Planning Staff Report
Greenville Planning Commission
February 7, 2022
for the February 16, 2022 Public Hearing

Docket Number:	MD 21-1004
Applicant:	DHD Riley, LLC / Drew Schaumber
Property Owner:	Wells Home Loan Servicing, LLC
Property Location:	South of Lowndes Hill Rd at Lockwood Ave, Adjacent to I-385
Tax Map Number:	0195000100201
Acreage:	5.89 acres
Zoning:	RM-3, Single- & Multi-Family Residential District
Proposal:	88-unit multifamily affordable housing development
Staff Recommendation:	Approve with Conditions

2 CLUBHOUSE FRONT ELEVATION RENDERING
SCALE: NTS

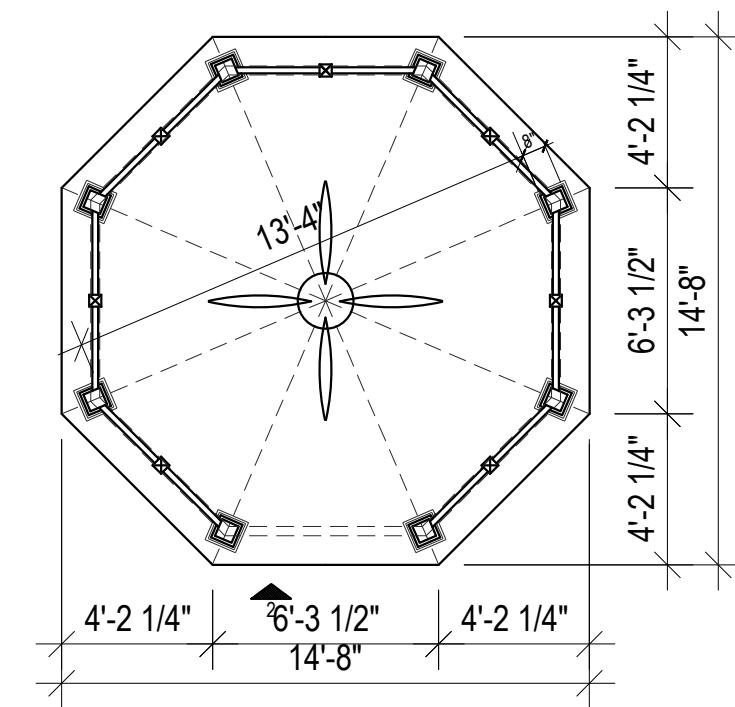
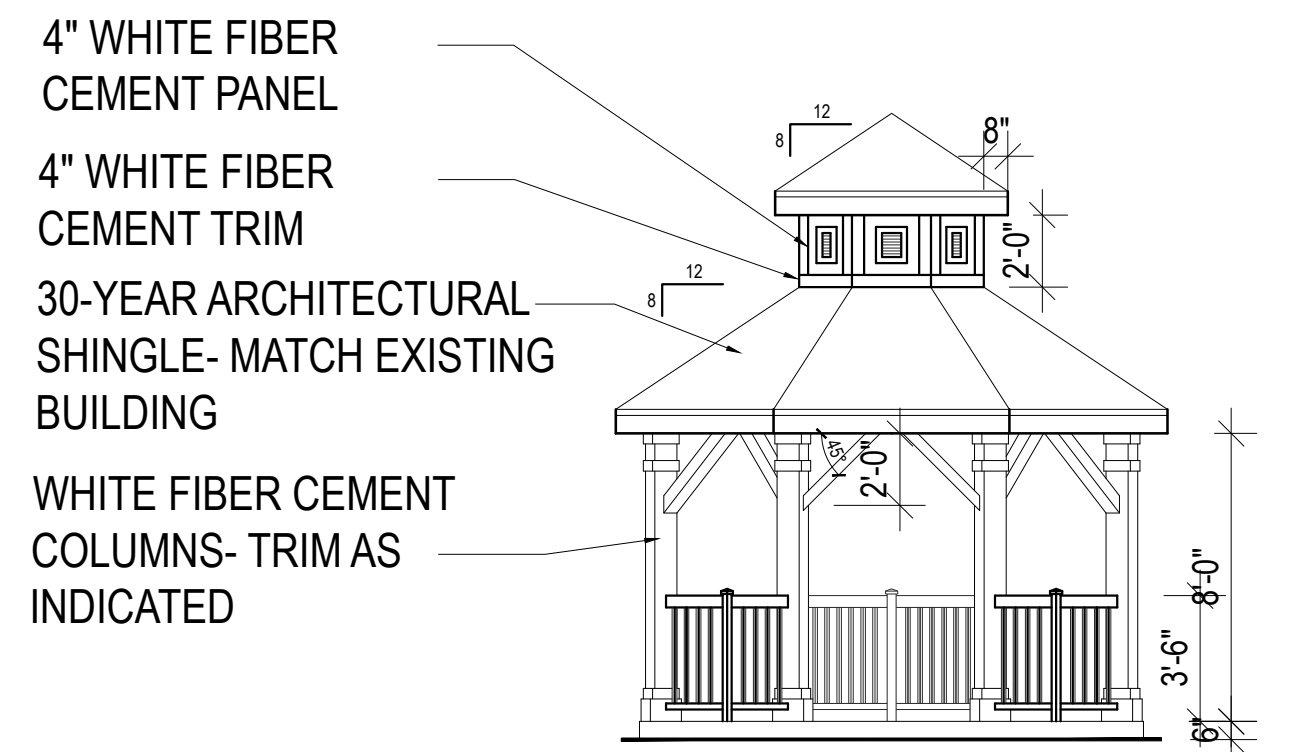
- The clubhouse should reflect similar design style to the main buildings.
- The statement that this is gateway architecture is a little amiss.
- The perspective drawings should show the buildings with the actual roofs as they are from a lower level so you can see what the actual view would be.

- 2) Prior to permitting, the applicant shall work with staff to provide updated façade materials for the clubhouse that are in keeping with those of the main buildings.

PAVING GRADING AND DRAINAGE PLAN

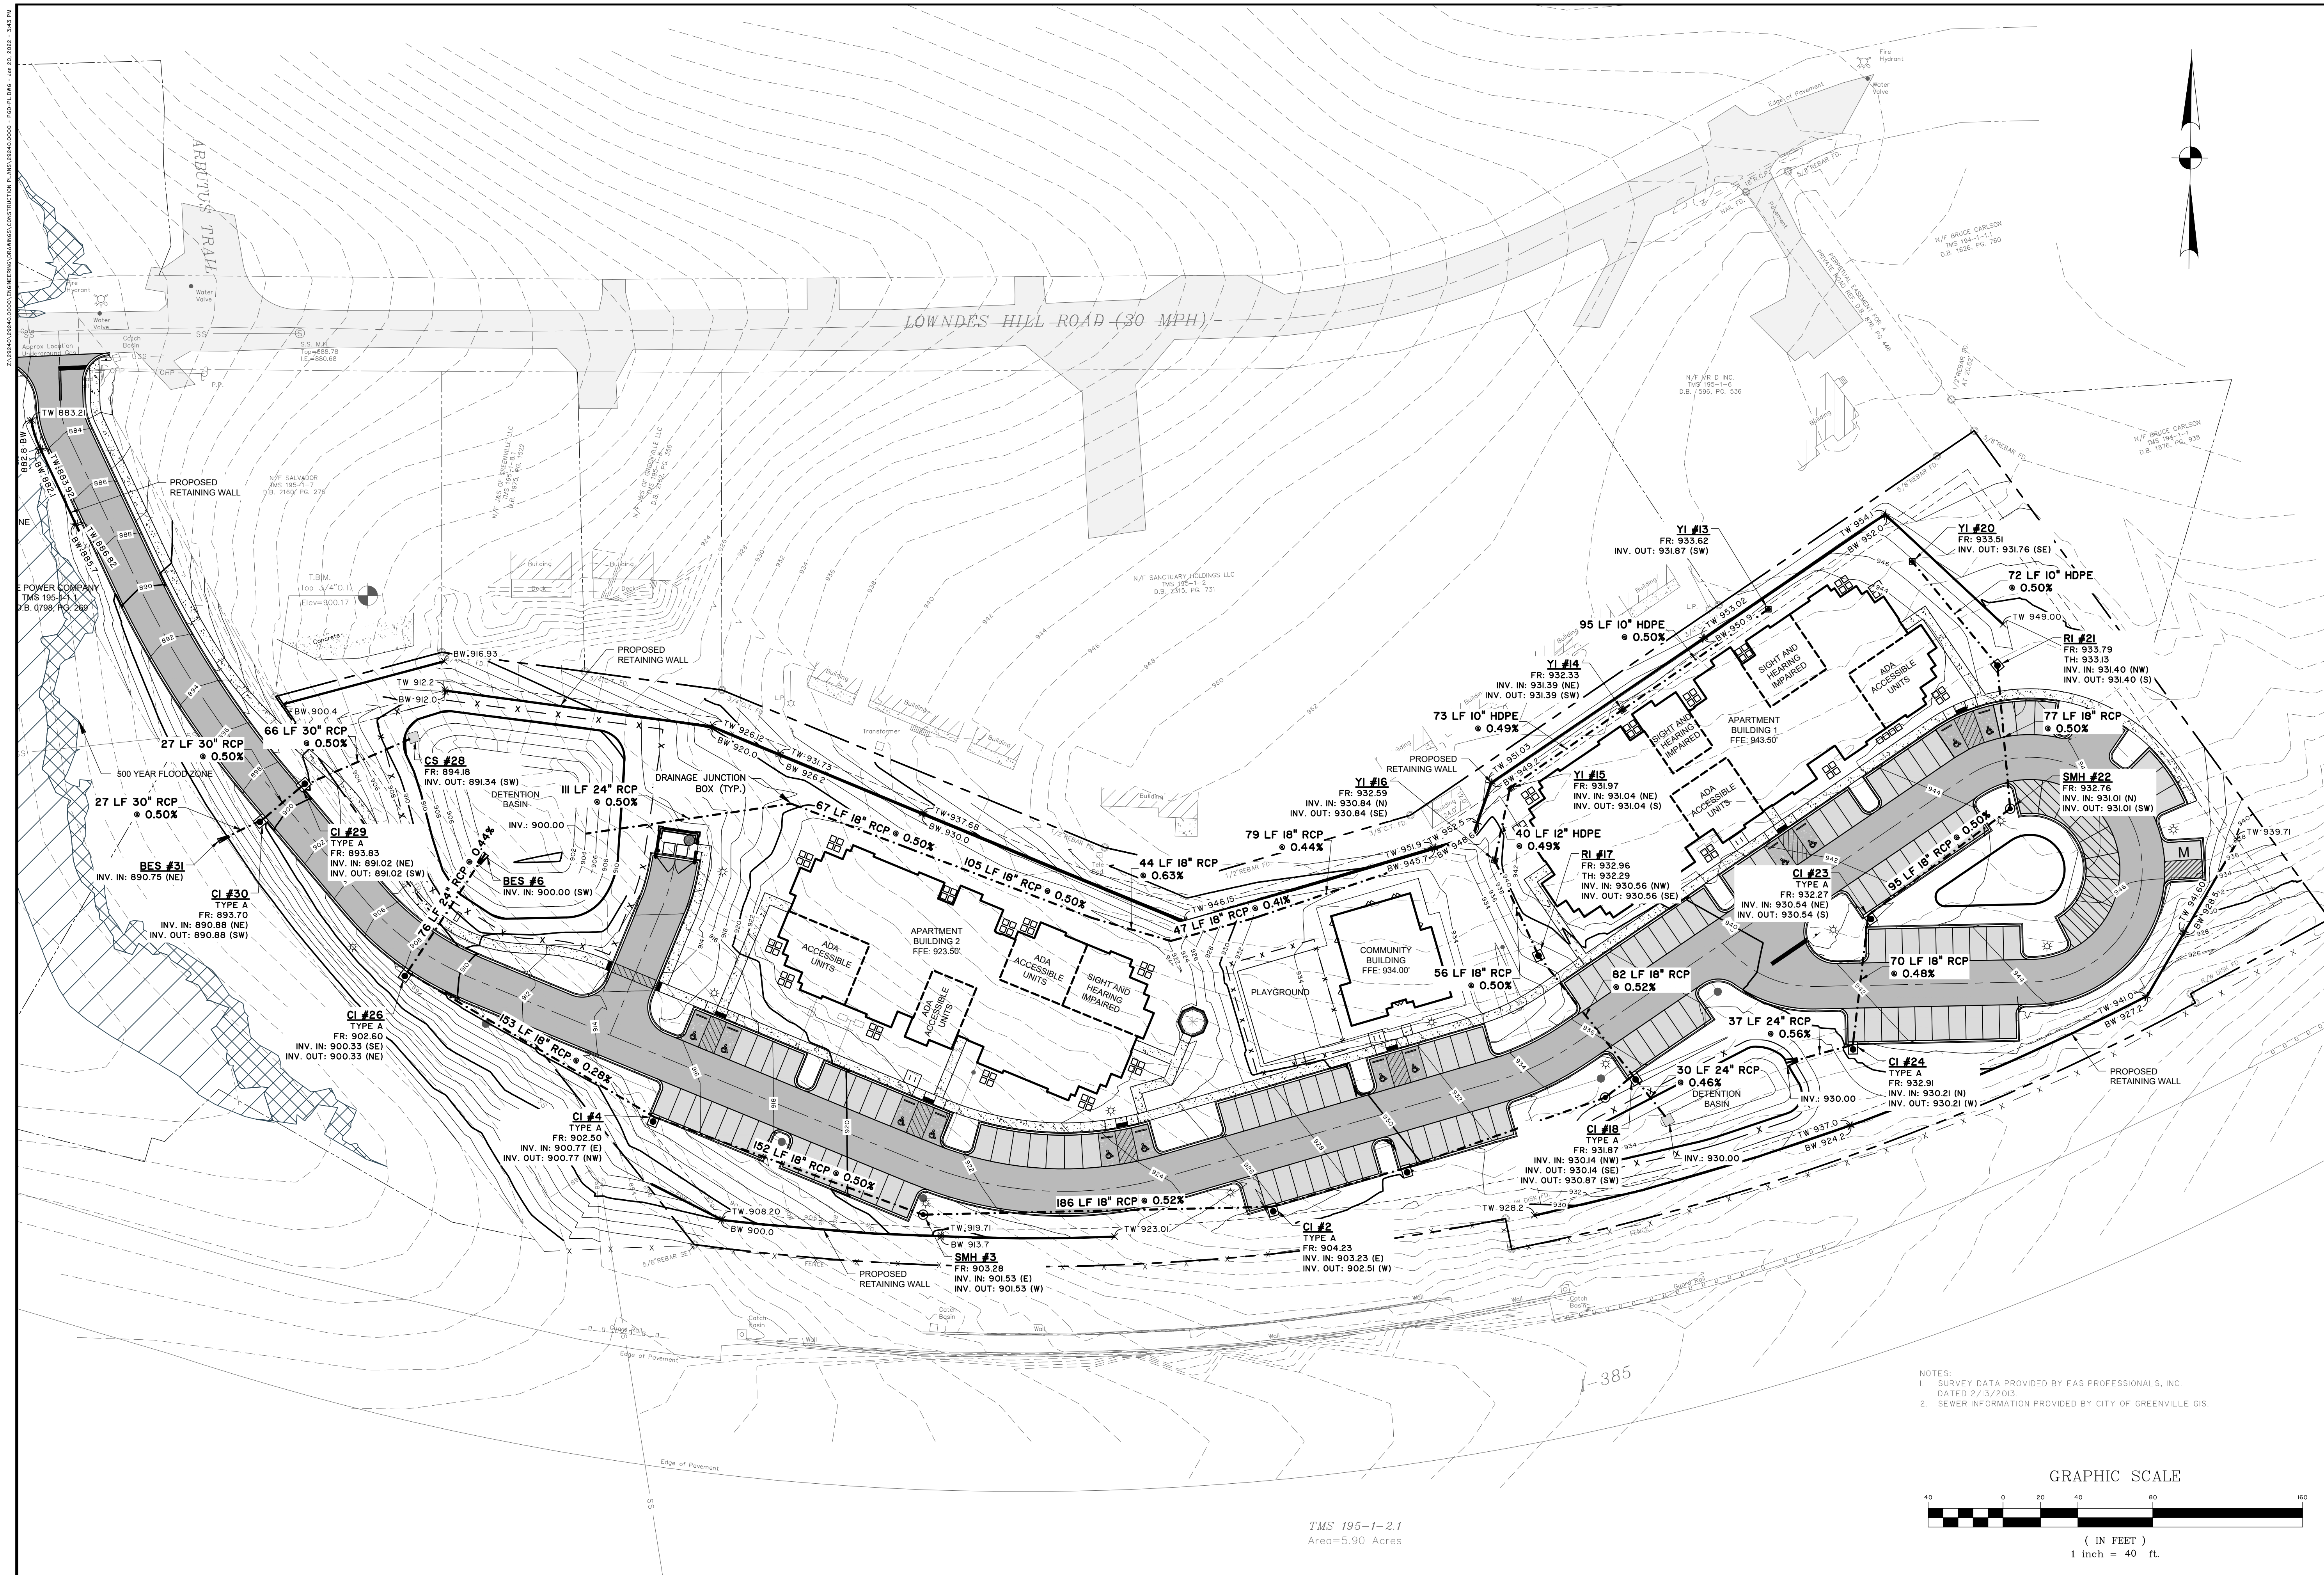
- A 6-foot wall has been provided along the adjacent single-family detached residential property line.
- A retaining wall is provided the rear of the property to address grading. A detail on the retaining wall was not provided.
- Black decorative fencing is indicated around the primary stormwater detention basin.
